Providence City Plan Commission

August 15, 2023

AGENDA ITEM 3 ■ 661-665 PLAINFIELD STREET

PROJECT OVERVIEW

Proposed landscaping plan

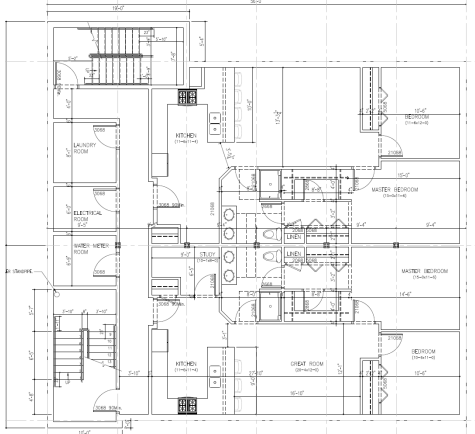
Lots in the C-1 zone require 15% of canopy coverage. The applicant is proposing to meet that requirement with a combination of street trees and plantings on the individual lots. The landscaping plan proposes a mix of small, medium and large trees planted around the site with pervious grassed areas and walkways between buildings. Planting rows of shrubs are proposed along buildings. The applicant will meet the canopy coverage requirement and the plan shall be subject to the City Forester's review.

1. The landscaping plan shall be subject to the City Forester's approval.
2. The applicant shall submit any required encroachment permits with the building permit application.
3. Final plan approval should be delegated to DPD staff.
